# Presentation to the Joint Review Panel for the Marathon Palladium Project

Presenter: Brooke Campbell-Paterson  
Regional Hydrologist

Topic: Hydrology

Presentation Date: March 17, 2022

CORMIX Modelling Results – Base Case

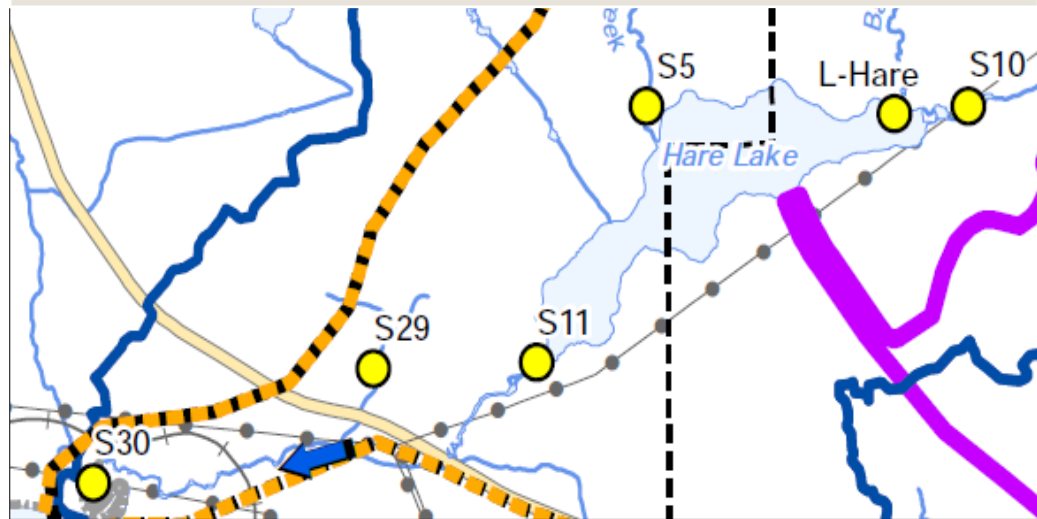
- Mine effluent discharge is proposed to be directed to Hare Lake (i.e., the receiver) during the operations phase
- CORMIX modelling was used to predict the maximum mixing zone extent. A mixing zone based on concentration (i.e., when concentrations return to applicable receiver criteria) will be required when effluent limits are developed.
- Potential for meromixis in Hare Lake was also evaluated using the CORMIX modelling.

- The proponent should re-evaluate the CORMIX modelling considering the  $7Q_{20}$  inflows/outflows (as well as the 1 in 20 dry year lake level) to Hare Lake.
- Worst-case scenario assessment should include the potential for zero flow at the outlet of the lake and potential mitigation measures that will be enacted by the proponent in this scenario.

Watershed 107 – Predicted Surface Water Quantity Change

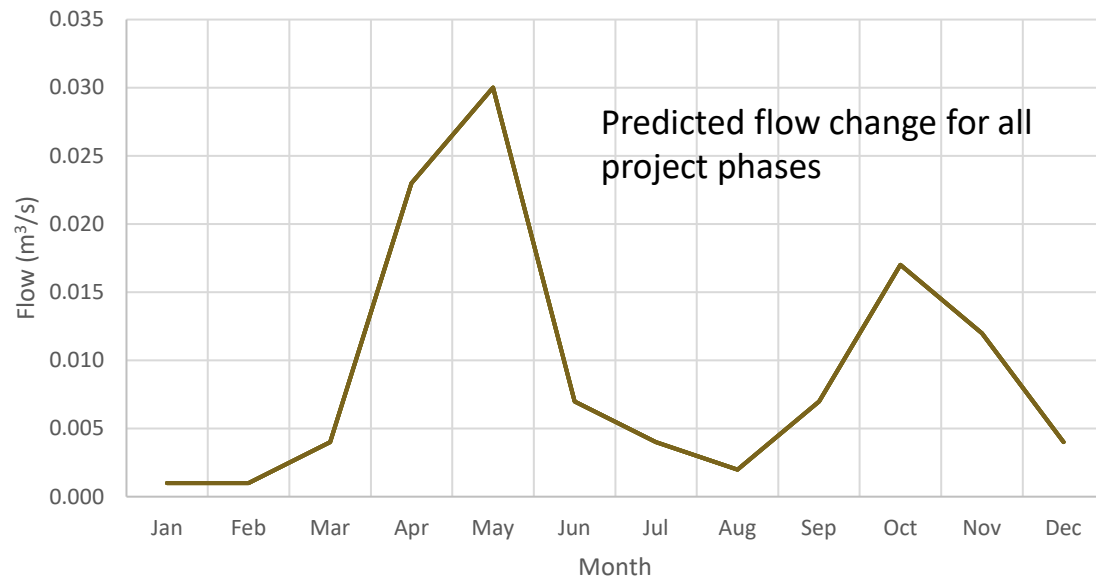
It is not clear if or how the groundwater losses to surface water features have been characterized as part of the assessment of potential impacts to valued ecosystem components

- The predicted impacts to the Mean Monthly Flows (MMF) in some watersheds within the project area do not appear to consider the changes in groundwater inputs
  - For example, the change in groundwater discharge to Watershed 107

- The proponent should comment on if or how the groundwater losses to surface water features have been characterized.
- Impacts to surface water levels resulting from the predicted reductions in groundwater discharge have not been quantified. The proponent should assess the potential for drawdown in lakes potentially effected by the project:
  - Terru Lake (~8% groundwater losses at end of operations)
  - Unnamed Lake in watershed 104 (~3.9% groundwater losses at end of operations)
- Monitoring, trigger values, and mitigation measures for water features potentially impacted by changes in groundwater inputs will be required for MECP permitting and approvals processes, should the project be given approval to proceed.

# Monitoring Program - Baseline Hydrology Stations

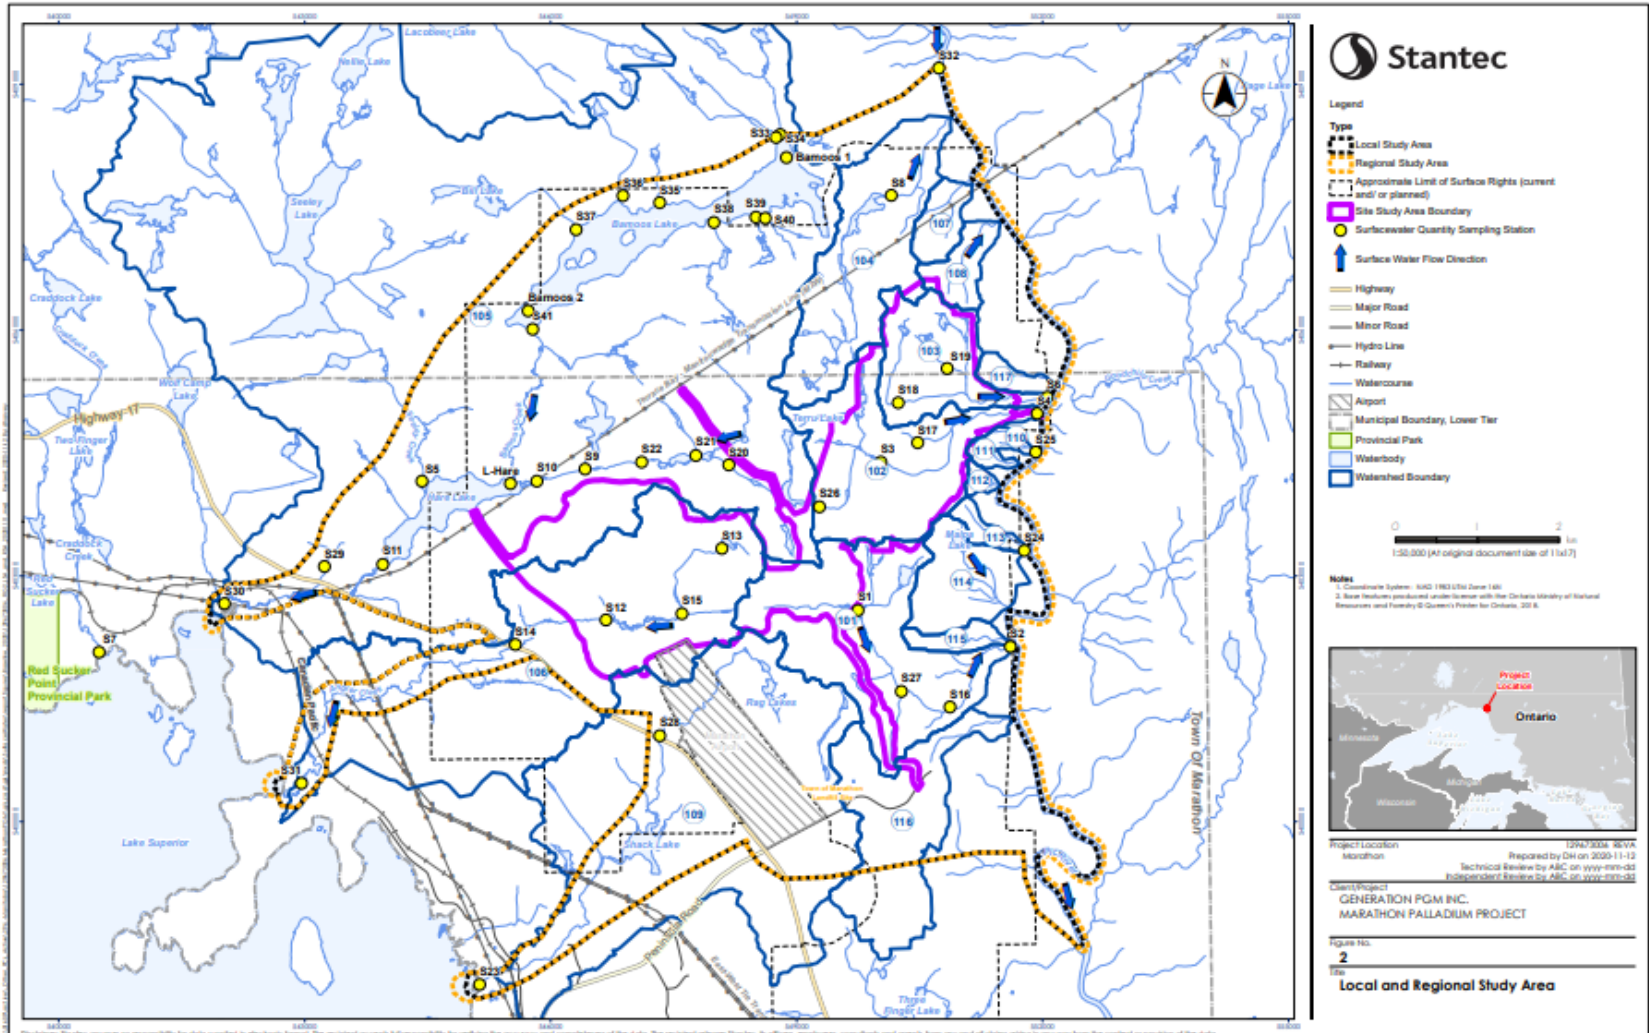
- Several on-site rating curves should be improved for some flow monitoring stations
- Temporal range of manual measurements should be included in baseline documentation

Station ID	Recommendations
S1, S2, S3, S4, S6	Monitor depending on finalization of DFO Approvals.
S8	Continue monitoring for baseline
S9	Continue monitoring for baseline
S10	Continue monitoring for baseline
S11	Continue monitoring for baseline
S24 (Outlet of watershed 113)	Add flow monitoring and develop rating curve
S25 (Outlet of watershed 110) <sup>1</sup>	Add flow monitoring and develop rating curve
Outlet of Watershed 108	Establish new stations depending on finalization of DFO Approvals.
Reference station(s)	Establish new stations or rely on existing stations that will not be impacted by the project. Add flow and water level monitoring for baseline.
